Item 4.**Development Application: 698-704 George Street, Haymarket****File No.:** D/2017/1787**Summary**

Date of Submission:	21 December 2017 Amended plans received 20 August 2018
Applicant:	Northpoint Construction Group Pty Ltd
Architect:	Architectus
Developer:	Northpoint Construction Group Pty Ltd
Owners:	Goulburn Property Pty Ltd - 51-57 Goulburn Street (Golden Dragon Pub) Haymarket House Pty Ltd - 698-704 George Street (Kiss's Building) Peter and Helen Kafataris - 43-49 Goulburn Street (Scruffy Murphy's Pub)
Cost of Works:	\$139,969,399
Proposal Summary:	<p>The application seeks concept approval for the following:</p> <ul style="list-style-type: none">• Demolition of No. 51-57 Goulburn Street, the potential demolition and/or retention of No. 43-49 Goulburn Street and the restoration of the Kiss's building, a local heritage item, at No. 698-704 George Street• Construction of a 40-storey tower with a podium ranging in height from 3-13 storeys and a single level basement• A mix of retail, hotel and residential apartments <p>The application seeks Integrated Development consent requiring approval under the Water Management Act 2000 for dewatering. General terms of approval have bee

Figure 11: The site (in red) and the neighbouring residential apartment buildings (in blue) included within the applicant's solar access study

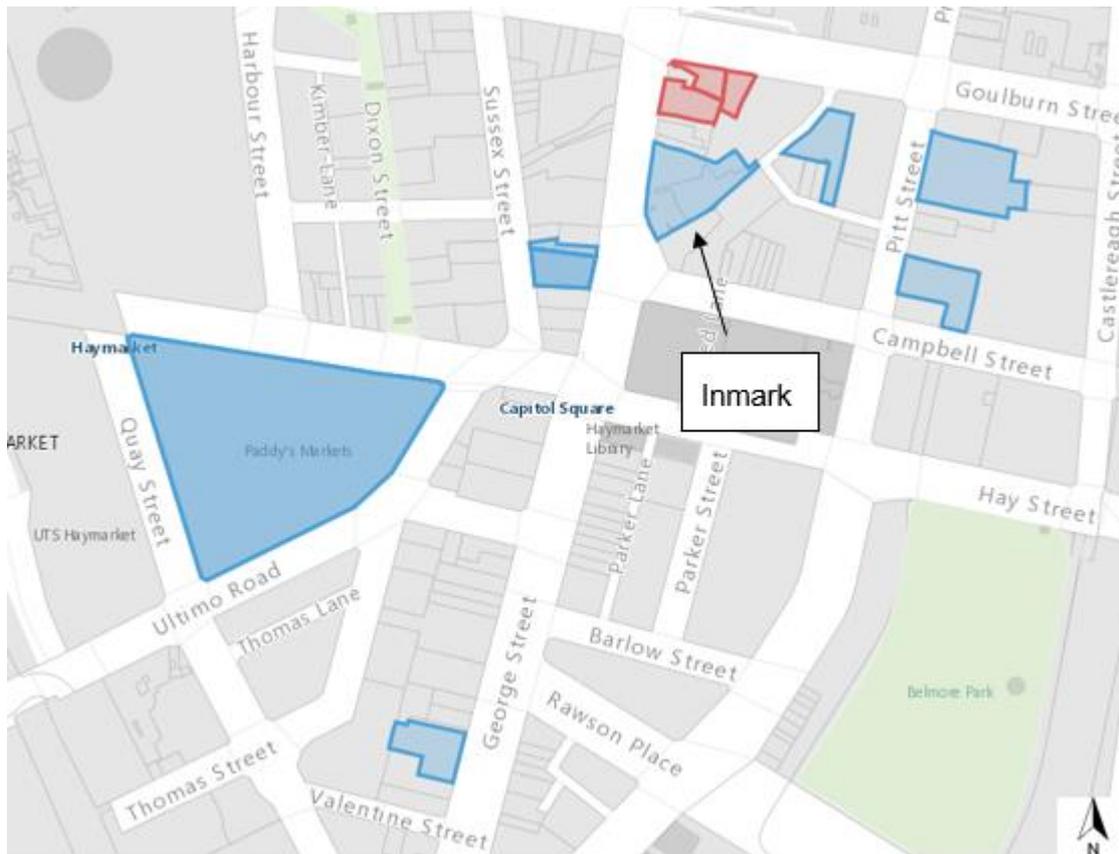
38. The proposed building envelope, as amended, will not adversely overshadow the apartment buildings located at sites (b) to (h) listed above. However, the building envelope will adversely overshadow apartments located within the Inmark building at 718 George Street.

Figure 13: The amended tower envelope required to retain solar access to 70% of apartments within the Inmark

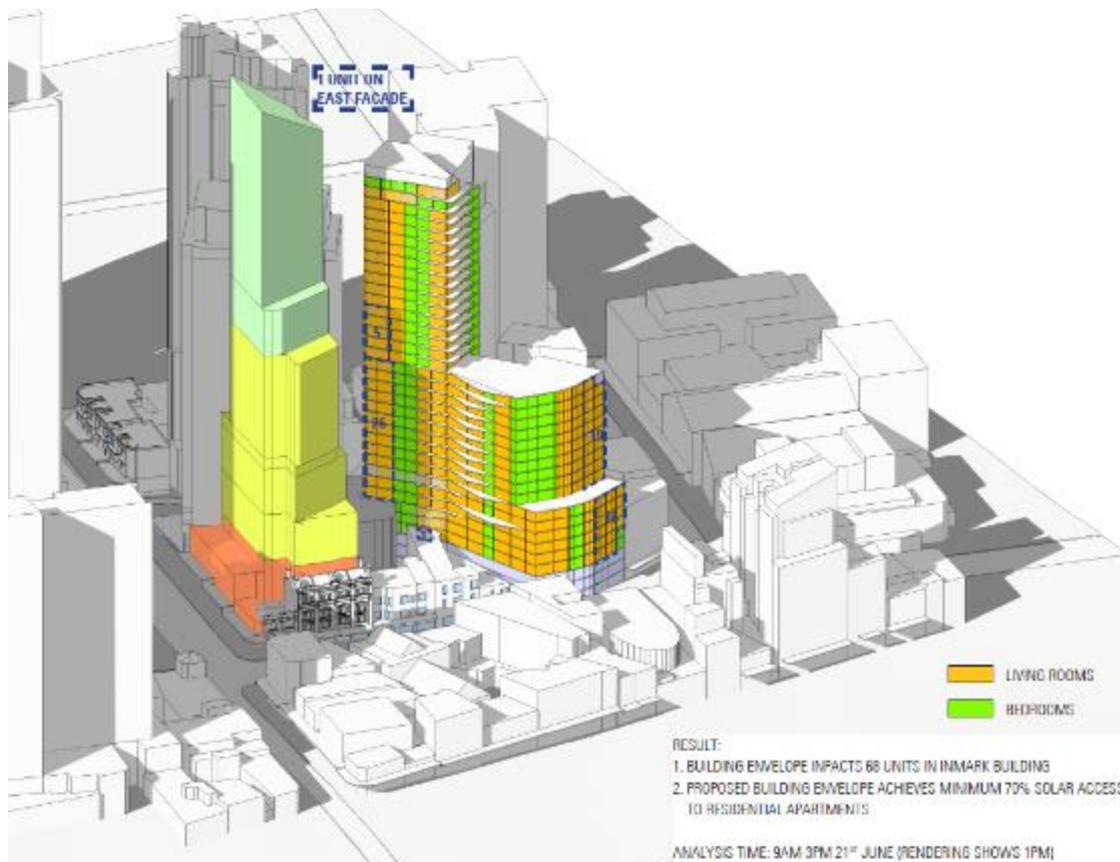
44. Officers requested modelling to demonstrate the impact to the building envelope if solar access was maintained to 70% of Inmark apartment living rooms and balconies from 9am to 3pm. This was requested as the design guidance regarding Objective 3B-2 also states that, where "the proposal will significantly reduce the solar access of neighbours, building separation should be increased beyond minimums contained in Section 3F - Visual Privacy". The figures below illustrate the significant setbacks to the western elevation required in order to maintain the minimum solar access to 70% of apartments in the Inmark building, and the impacts this has to the form and yield of the tower. Note that the western elevation is the prevailing area overshadowing the Inmark building rather than building separation or the overall height of the building.

45. It is noted that in order to meet the minimum required solar access to the Inmark building, the indicative gross floor area of the amended building would be reduced from 17,488.4sqm to 13,934.1sqm (-21%), the resulting form limits the flexibility of the hotel and residential floor plates. Furthermore, the applicant did not provide any additional information regarding the extent to which the amended building envelope overshadows neighbouring apartments such that they receive no solar access in midwinter.

Figure 24: A 4.2 metre setback is provided between the eastern elevation and the commercial tower from ground level to the commercial tower, closest to Goulburn Street, and a nearly nil setback towards the rear

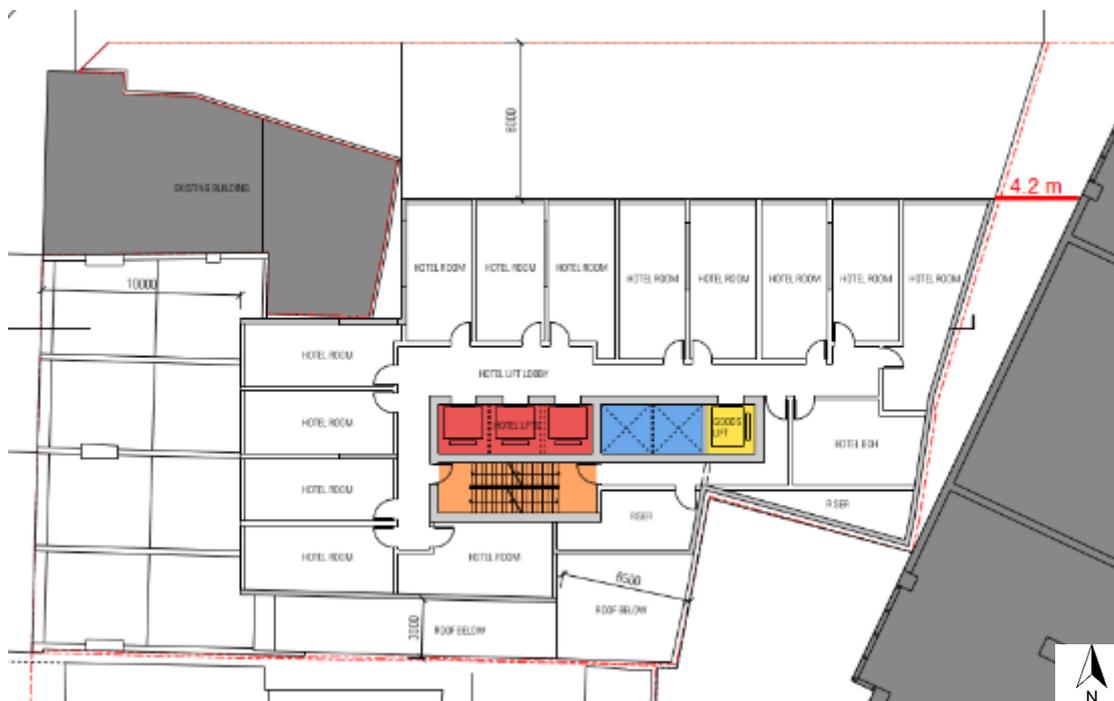
- (a) The proposed tower envelope (and indicative reference scheme) is too close to neighbouring towers. The application is to be amended such that a 10 metre minimum separation is provided between the existing neighbouring commercial tower at no. 59 Goulburn Street and the proposed envelope.

Response - The envelope has been amended to provide a 6 metre setback from the boundary with no. 59 Goulburn Street above 45 metres. A nil setback is provided between ground level and 45 metres. The figures below illustrate the setbacks from the boundary and the commercial tower.
